# Response to the AER Explanatory Statement on Powerlink's proposed Service Target Performance Incentive Scheme

1 July 2012 to 30 June 2017  
Regulatory period

**Powerlink Queensland**  
**Response to the AER Explanatory Statement on Powerlink's proposed**  
**Service Target Performance Incentive Scheme**

**Figure 1 - Queensland Average Demand (MW) (from 2007-2010) Profiles**

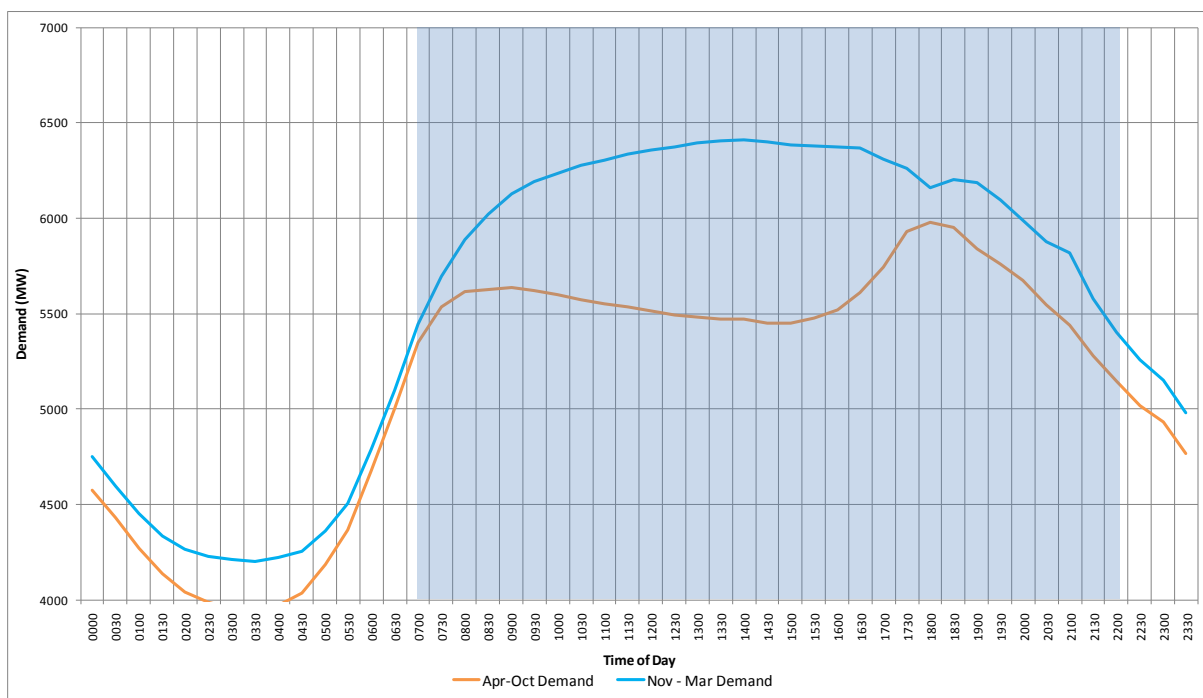
As suggested by the AER<sup>6</sup>, Powerlink agrees that demand in the Queensland transmission network can be fairly constant across traditional ‘peak’ periods. Figure 1 shows the Queensland daily demand profile for November to March and April to October periods. The data has been averaged from June 2007 to June 2010. The information supports the AER’s statement and demonstrates that Powerlink’s peak system load starts around 07:00 in the morning and continues through to 22:00 in the evening during the summer months. The chart clearly shows that demand is flatter and higher during the November to March period when compared to the April to October period. It also illustrates the period when

transmission network users place greatest value on the reliability of Powerlink’s transmission system is the summer months between 07:00 and 22:00.

To address the AER’s concerns, Powerlink proposes Transmission Circuit Availability (Peak Periods) as an additional transmission circuit availability sub-parameter. Transmission Circuit includes the individual plant of transmission lines, transformers and reactive plant, which is consistent with the definition in Powerlink’s existing scheme. “Peak Periods” refers to the months from November through to March, with a time period from 07:00 in the morning to 22:00 in the evening. It is further proposed that weekends and public holidays are not included in the sub-parameter.

The “Peak Period” months have been proposed on the basis that they exclude the “off-peak” months of April to October (accepted by the AER for the exclusion of capacitor banks). The proposed time interval (as detailed in blue in Figures 1 and 2 above), and the exclusion of weekends and public holidays is the same as the peak time period for Powerlink’s existing

**Figure 2 - Queensland Average (\$/MWh) (from 2007 to 2010) Profiles**

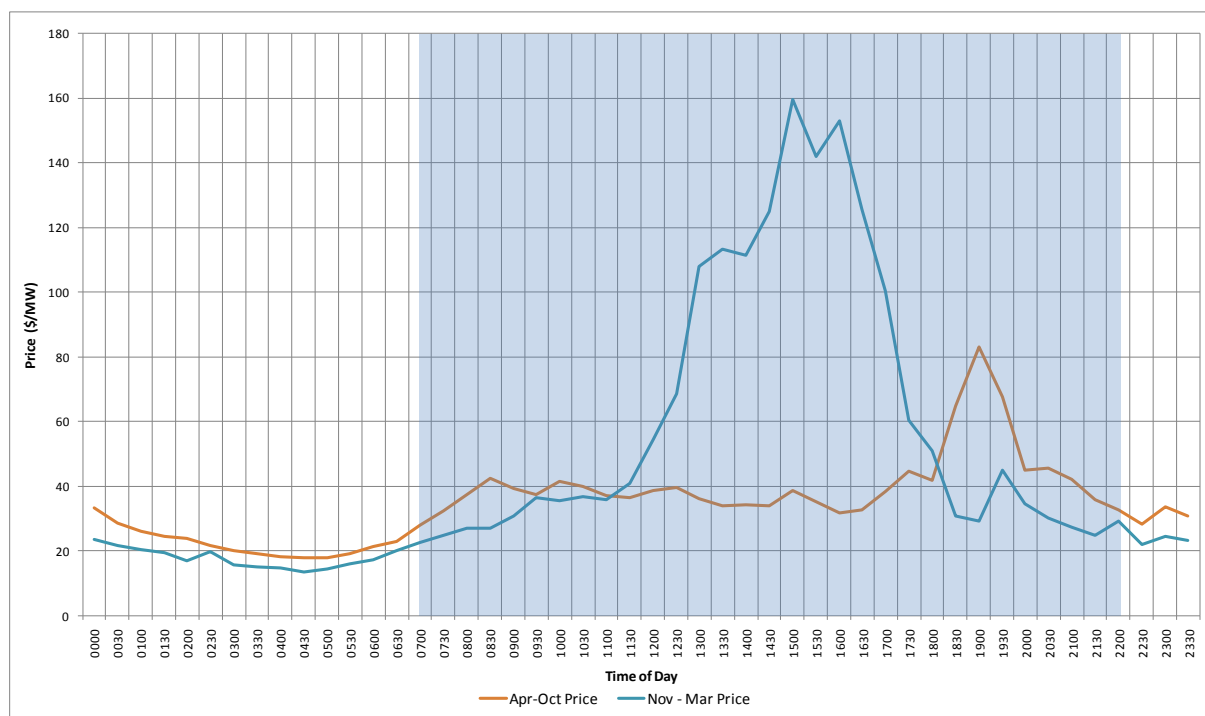
Similarly, Figure 2 shows the Queensland wholesale electricity price for the November to March and April to October periods. The data has been averaged from June 2007 to June 2010. The chart shows that Queensland’s electricity price typically peaks from 12:00 noon through to 18:00 in the early evening. As a result, in Queensland, this is the period when the reliability of transmission system elements has most potential impact on spot prices.

**Figure 3 - Embedded Generator Connection back to Powerlink’s Substation**

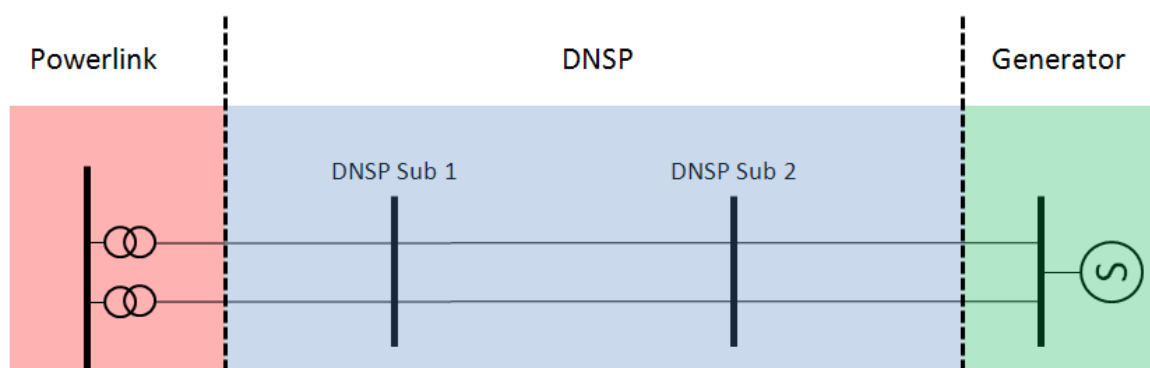
In the Queensland electricity network, a typical embedded scheduled generator connects radially through the DNSP’s network to Powerlink’s transmission substation (as shown in Figure 3 below).

Due to the nature of the generator connection, an outage to the transmission or distribution network could result in a difference in the shadow pool price of greater than \$10/MWh. Consequently, if Powerlink were to take an outage at its substation (shown in red in Figure 3)

that affects the connection of the generator, it could incur a dispatch interval count and impact the market.

To minimise the impact to the market, there should be an incentive for Powerlink to seek out opportunities where outages to its substation can be co-ordinated with outages to the DNSP's network. This is akin to the AER stated definition that permits TNSPs to equally share dispatch intervals.

Powerlink understands that an MITC incentive scheme does not currently apply for DNSPs. However, an outage taken by the DNSP on its network (shown in blue in Figure 3) has the same potential to impact the market as an outage at Powerlink's substation.

The AER suggests that if the proposed amendment was allowed, Powerlink would be able to effectively "collude" with DNSPs and operate in a manner that would be to the detriment of the NEM<sup>23</sup>. Powerlink strongly refutes the AER's suggestion that it would operate in a manner contrary to the NEO and good electricity industry practice.

It is therefore recommended that the AER include the amendment the definition of the Market Impact Performance Component in Appendix C:

"where the information described in (1), (2), (3) or (4) indicates that a TNSP together with one or more DNSPs are responsible for a single network outage constraint, the TNSP is apportioned an allocation of the number of dispatch intervals that reflects the number of NSPs responsible for the network outage constraint"
